Addendum 1 for RFB 953200-01

Project Name: DCI – ANK Room A155, A156 and A157 Renovation

Date: 6/29/2026

DCI - ANK Room A155, A156 and A157 Renovation – ADDENDUM #1

ELECTRICAL DEMOLITION & SCOPE PLAN
Sheet Number

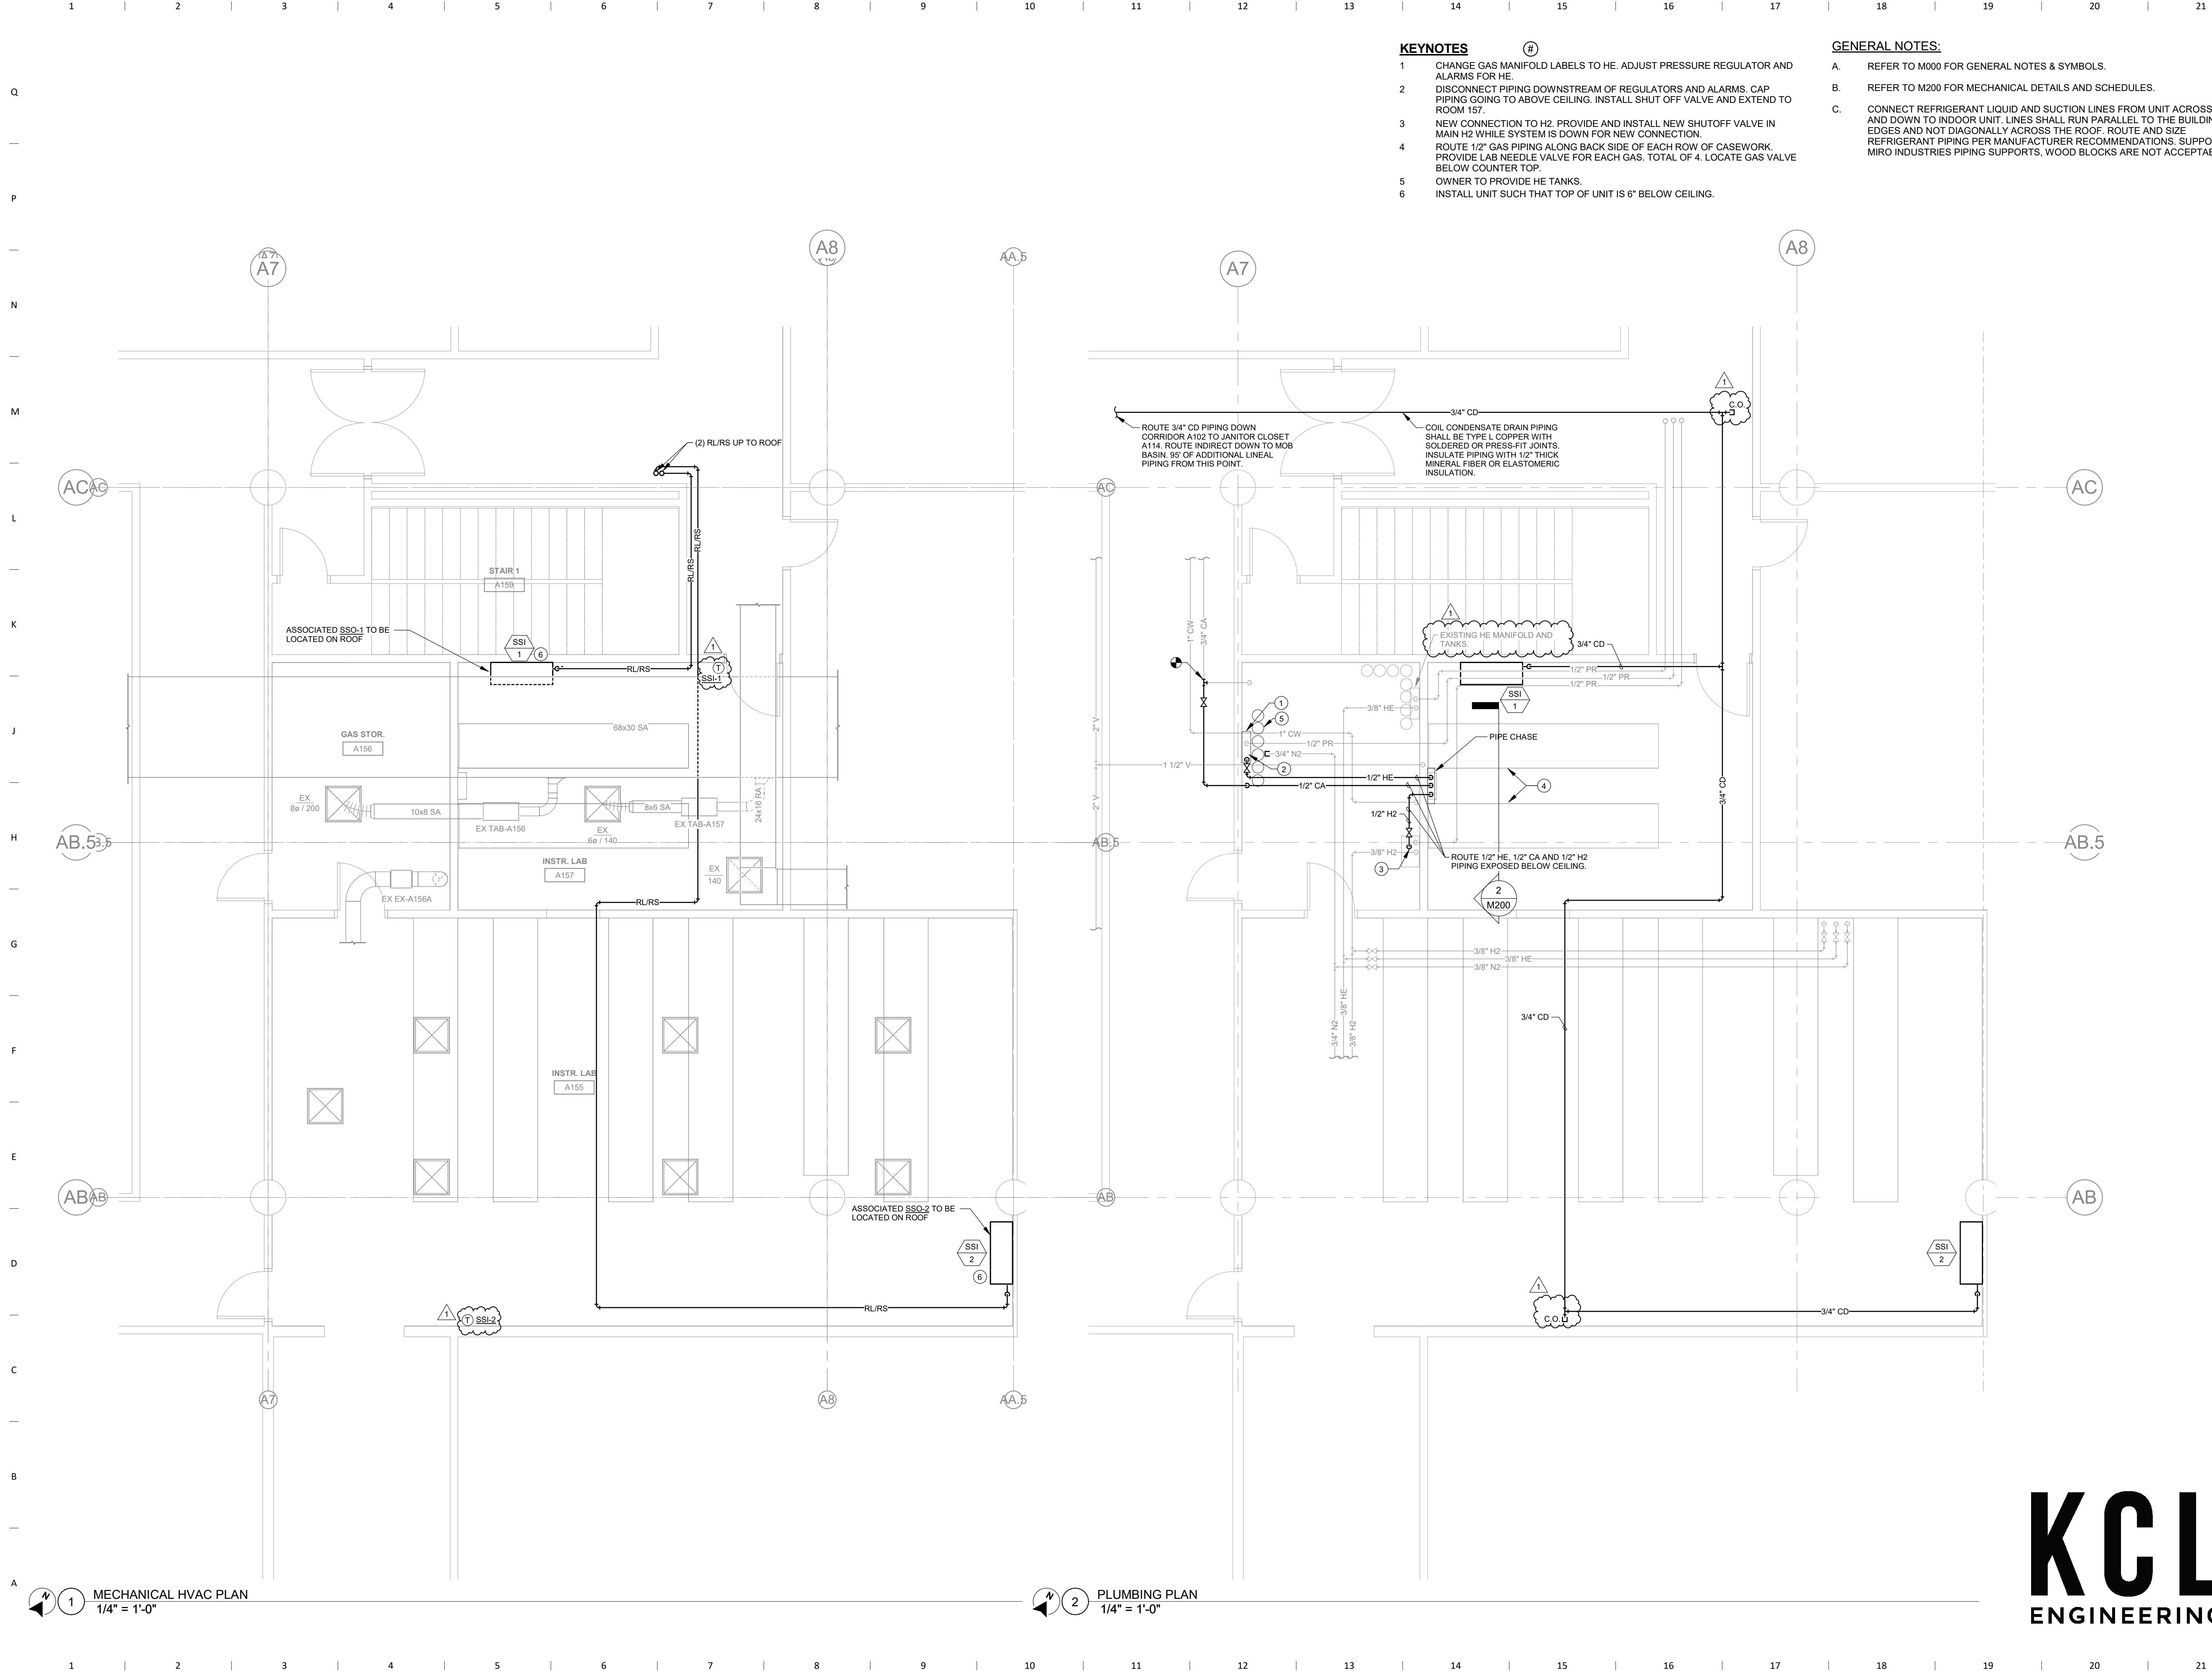
- d. Electrical Drawings:
 - i. Drawing ED101 – ELECTRICAL DEMOLITION & SCOPE PLAN
 1. ADD demolition sheet for scope of removing fixtures, devices, etc. Routing, panel, IDF room shown on view 2.

1. Drawing ED101 – ELECTRICAL DEMOLITION & SCOPE PLAN
 - a. **ADD** demolition sheet for scope of removing fixtures, devices, etc. Routing, panel, IDF room shown on view 2.
 - b. Refer to attached full size sheet ED101.

OPN Project No.
26819000
Sheet Issue Date
100% CD SET 06/02/26
Sheet Name
MECHANICAL HVAC PLAN
Sheet Number

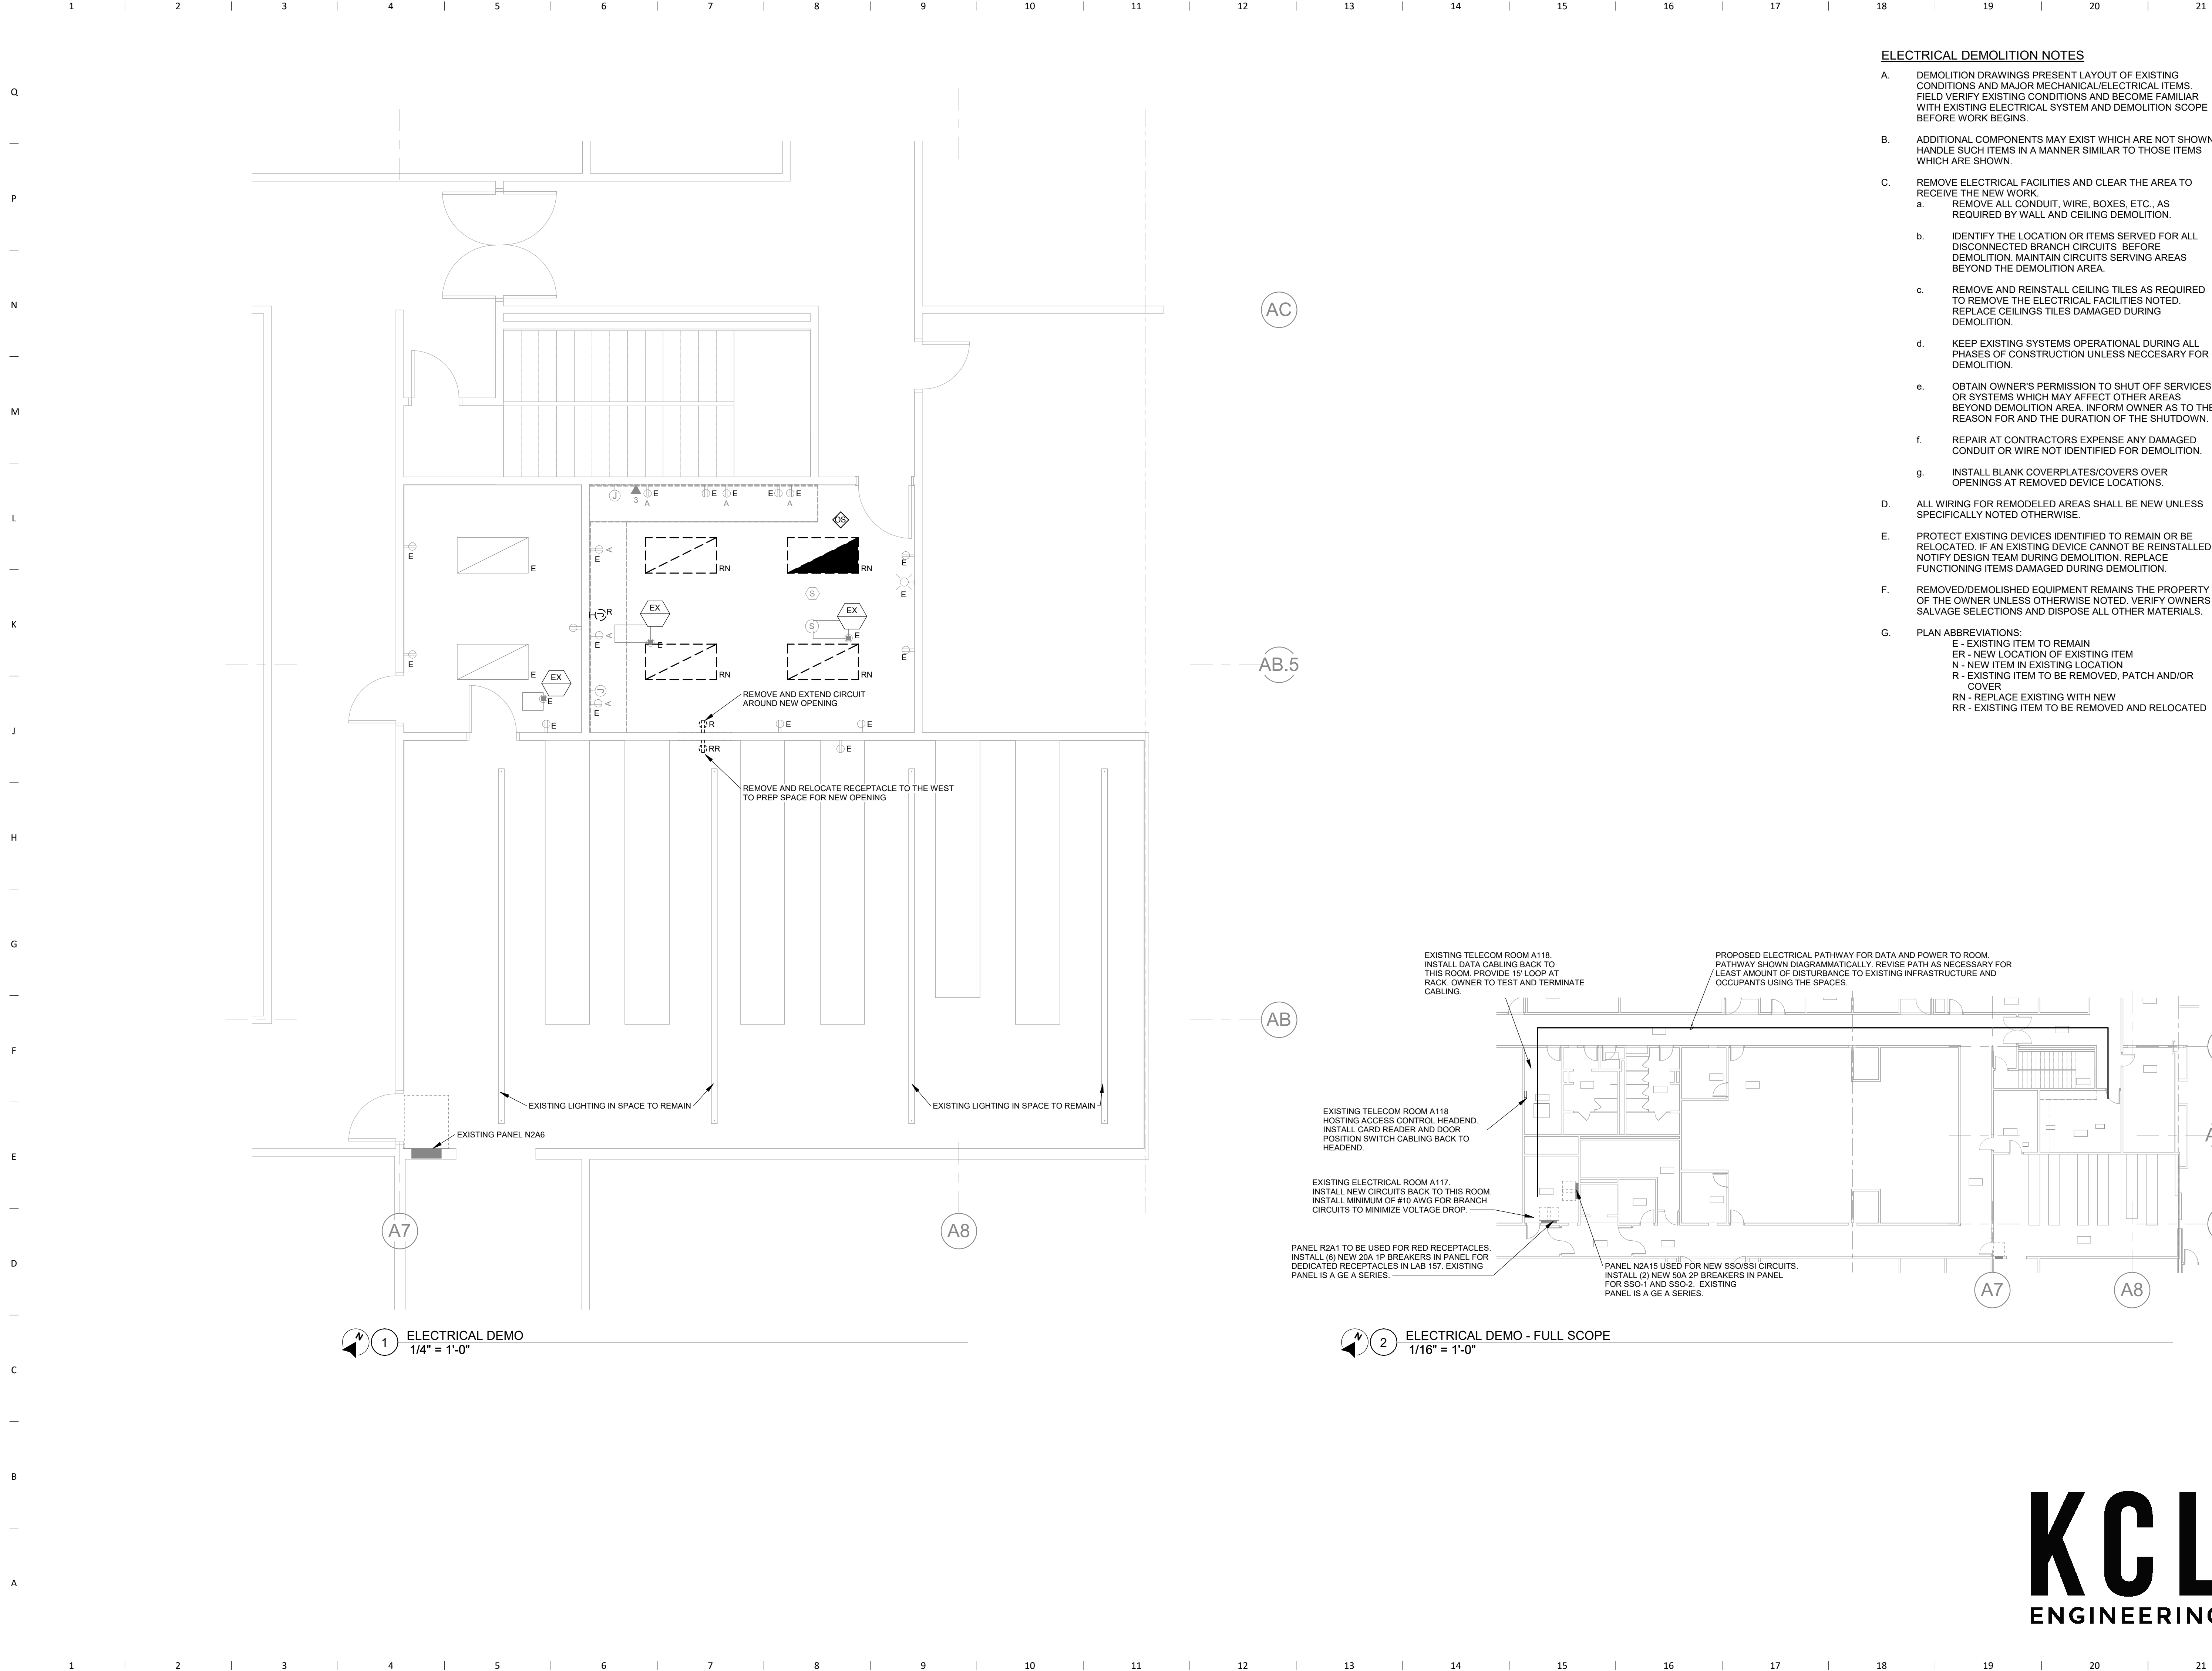
2. CLARIFY there is no new connection to the helium manifold in the northeast corner of the room.
 3. CLARIFY Location of thermostats for SSI-1&2.
 4. Refer to attached full size sheet

3. M101 - MECHANICAL HVAC PLAN:
 - a. **ADD** cleanouts for condensate piping in 2 locations.
 - b. **CLARIFY** there is no new connection to the helium manifold in the northeast corner of the room.
 - c. **CLARIFY** Location of thermostats for SSI-1&2.
 - d. Refer to attached full size sheet.
4. M200 - MECHANICAL ROOF PLAN, DETAILS, AND SCHEDULES:
 - a. **CLARIFY** Detail 4, Condenser Support detail: Minimum height of support curb to be 24” above roofing.
